Date: June 17, 2023

From: Randy Hart, Principal

Re: Sunrise of Newton Senior Living Facility
Transportation Peer Review; BETA June 7, 2023

Issued for: **Special Permit Application**
 Not Approved for Construction
 Drawing Title: **Site Layout and Materials Plan**
 Drawing Number: **C4.00**
 Sheet: **5** of **15**

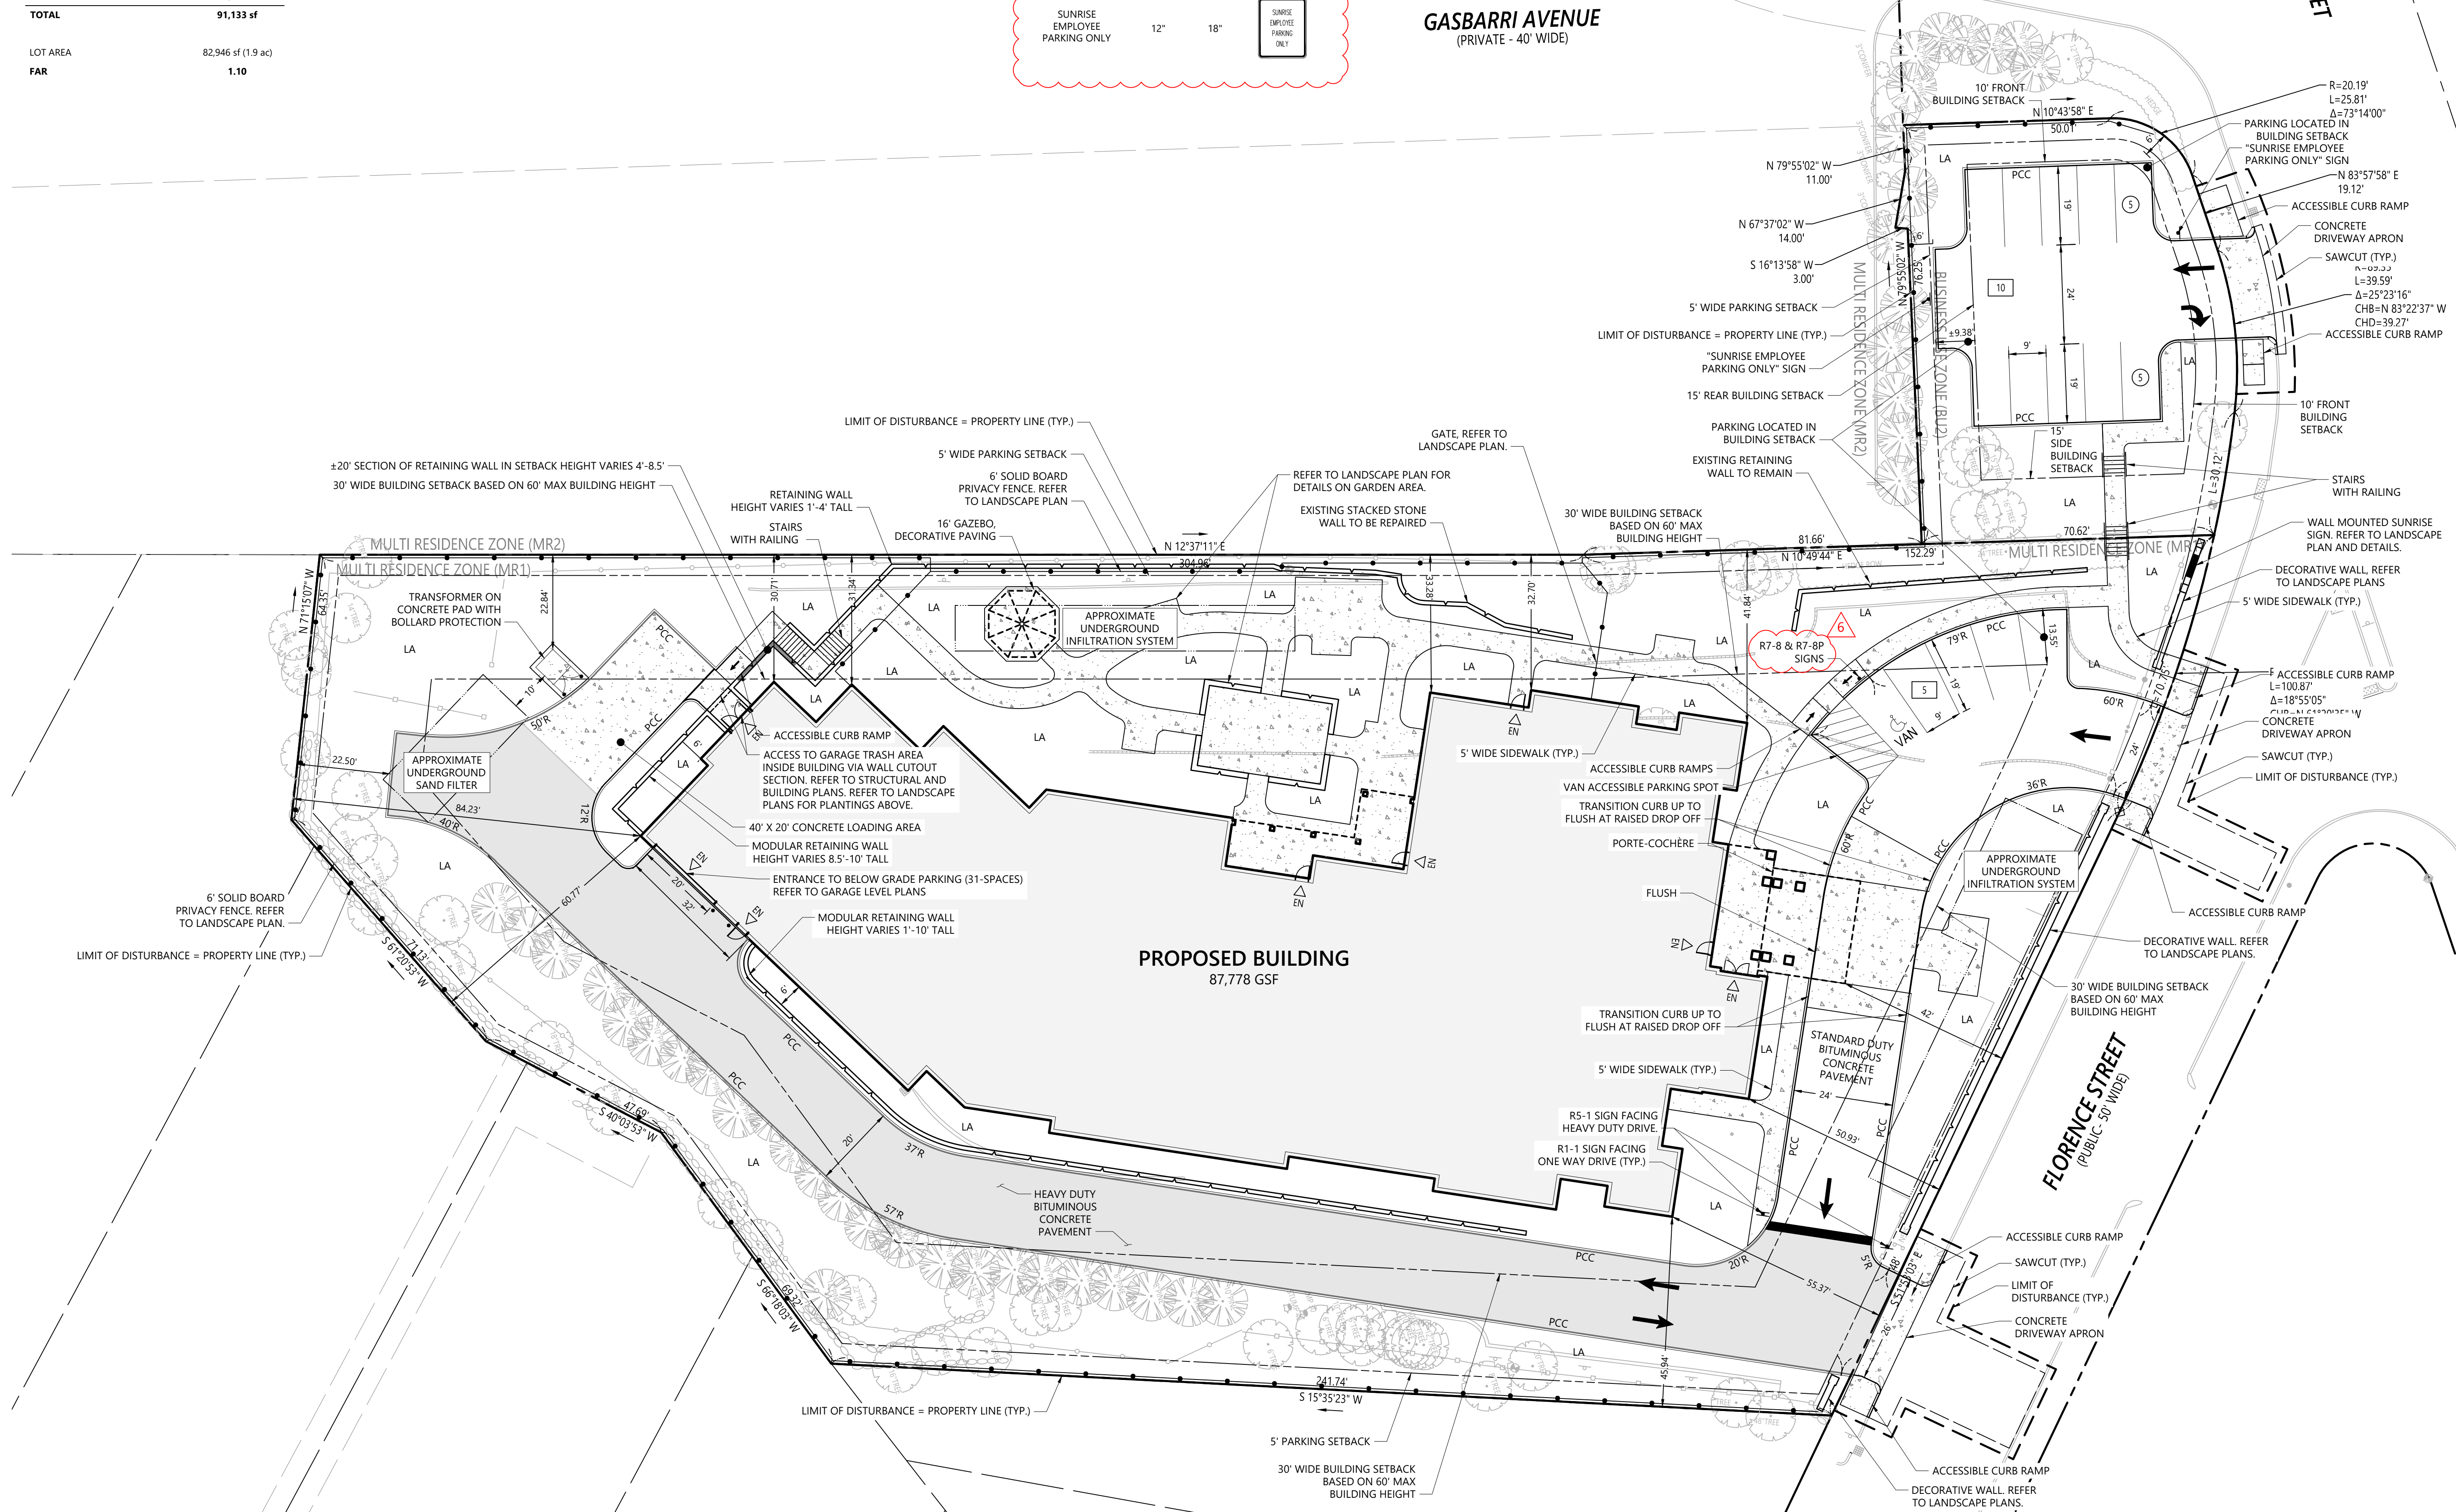
Comment: Response to comment 23 states that Plan Sheet C4.00, Site Layout and Materials Plan, contains all the proposed signage and pavement markings. Please review, since the latest plan set provided; dated April 4, 2022, contains proposed signs that are not labelled. For example, there is a sign shown adjacent to the van accessible parking space that is not identified. In addition, the legends associated with the sign identification numbers shall be provided.

Response: Plan Sheet C4.00, Site Layout and Materials Plan has been modified to address the signage and pavement marking comments. Revised version is an attachment to this document.
